**MEETING OF THE
PLANNING AND ZONING BOARD
QUASI-JUDICIAL PUBLIC HEARING**

September 24, 2019

Subject: Site Development Plan Application
Millennium Ambianta Multifamily Residential Complex (30 DU)
9901 West Bay Harbor Drive
Bay Harbor Islands Acct. No. SPR19-00005
MMPA Acct. No. 01-0702-1078

**Site Development Plan Application
Millennium Ambianta Multi-Family Residential Complex (30 DU)
9901 West Bay Harbor Drive
Planning and Zoning Board Staff Report
August 27th, 2019
Page 2**

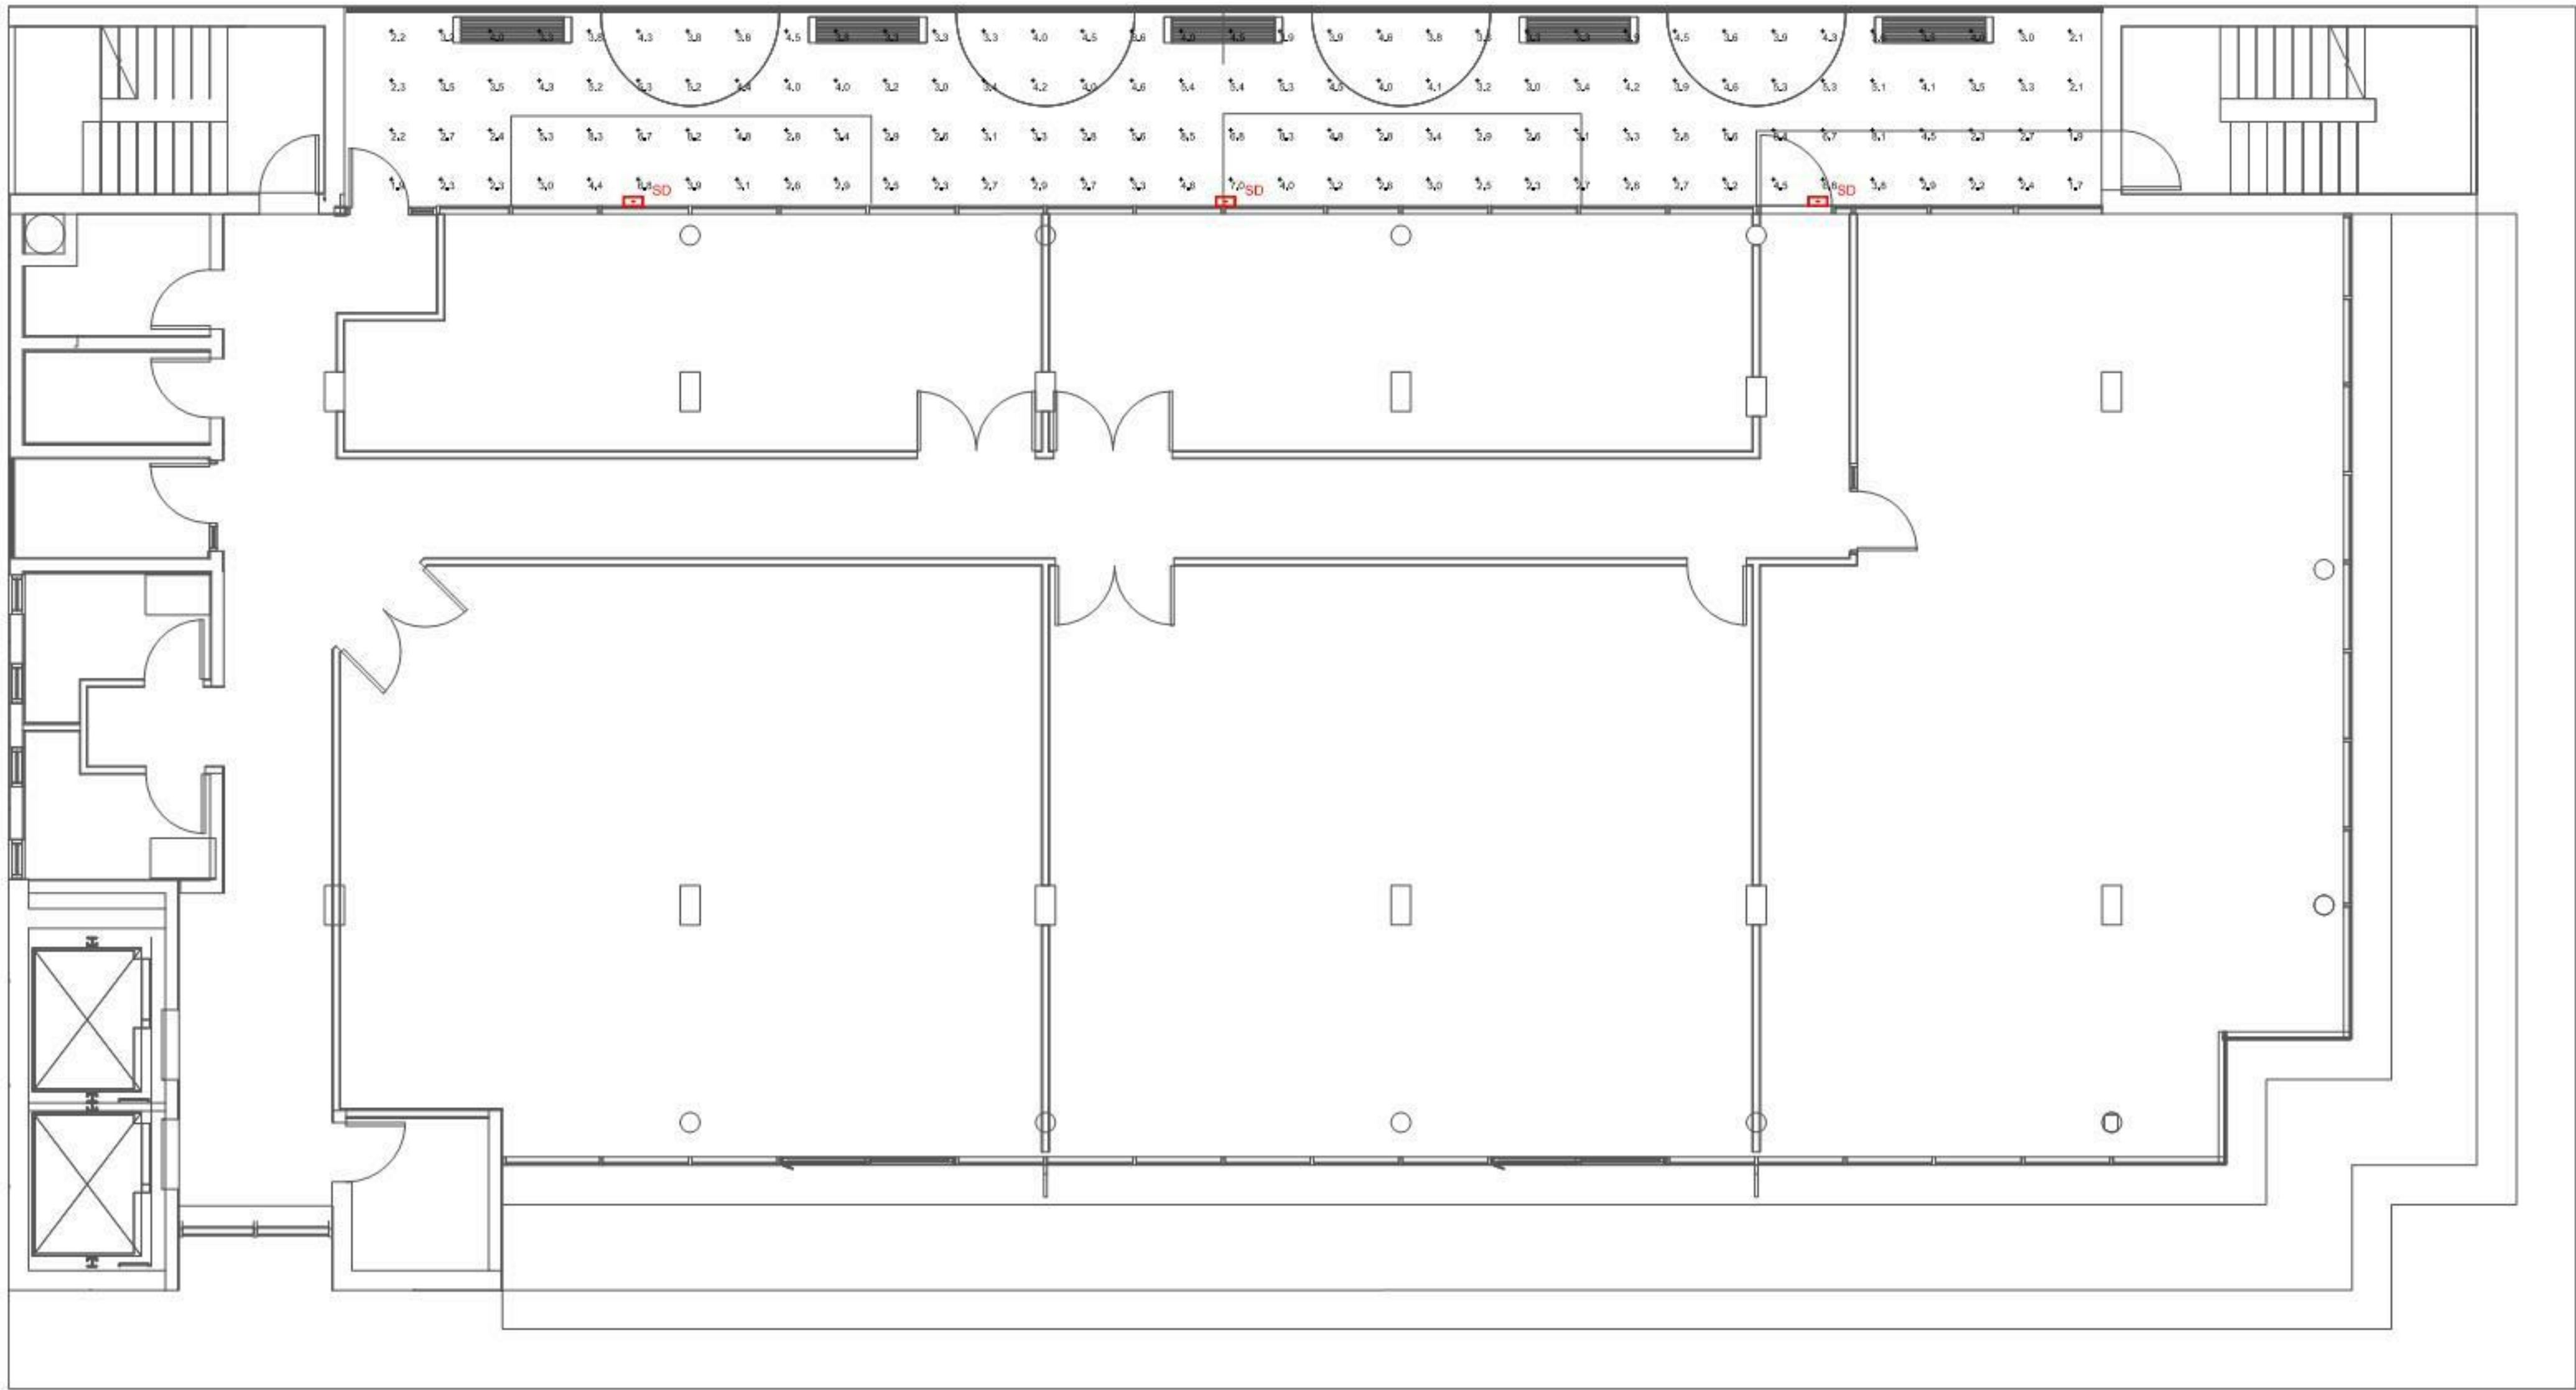
6. Outdoor Lighting Plan - The preliminary Photometric Lighting Plan shows compliance on the perimeters but does not indicate the levels within the site (pick up/drop off area / yards / rooftop / etc.). Prior to the issuance of building permits a complete Photometric Plan meeting the Town's Code requirements must be submitted / signed-off.

LANDSCAPE PLAN SC: 1/8"

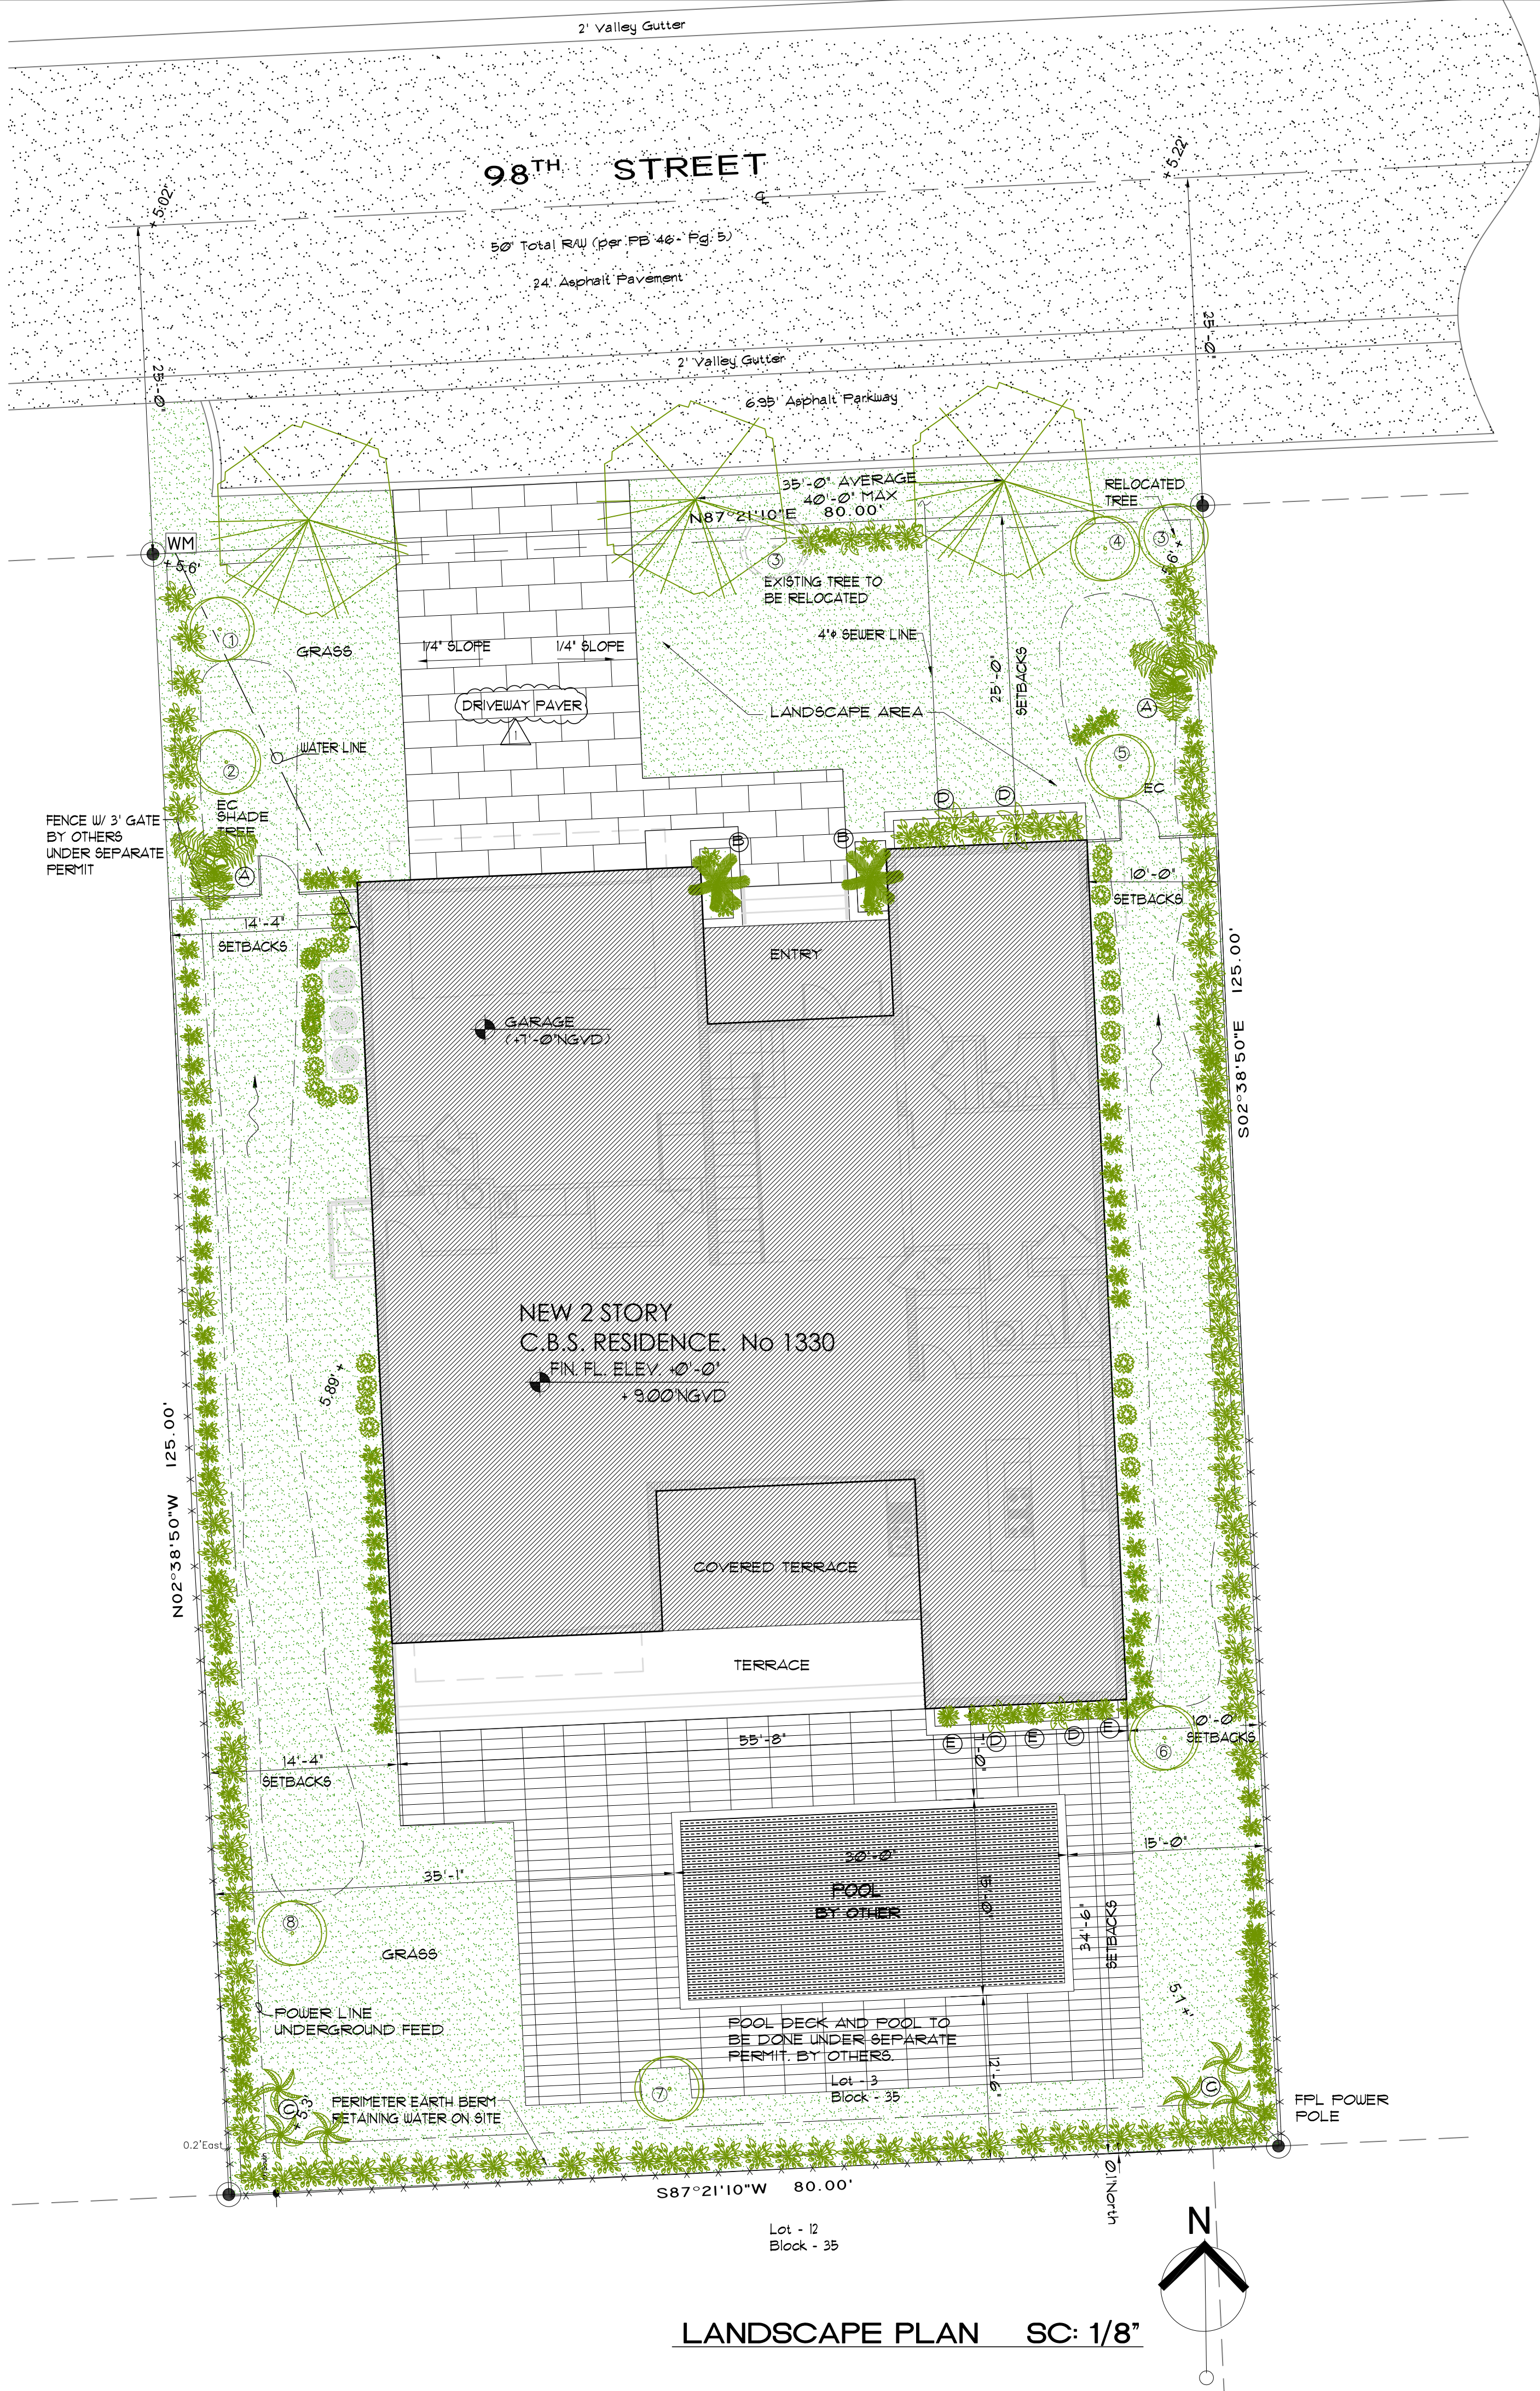
6. The landscape plan needs to be revised. New trees and shrub shown on the landscape plan reviewed at Planning & Zoning Board hearing of July 2, 2019 are not on the current landscape plan sheet LP-1. The plant schedule denotes Trees: two (2) new Alexander Palms, Six (6) new coconut palms. Royal Palm were reduced from seven (7) to two (2) on the current landscape plan. Three (3) monogamy tree should be revised to live oaks which is the required street tree. The size should also be 15' Height x 5' spread at planting. Shrubs: Beauty Bush (Callicarpa American) has been reduced from 70 to 60. Zamia Pumila (Coontie Palm) has increased from 10 to 14. Two new shrubs have been added to the plant schedule: (103 +/-) Pimienta (Calusia Hedge)- 3 gallon and along with (3) Cyanthea Cooperi. The (70) Pimienta (Calusia Hedge) have been removed from the proposed shrub list.
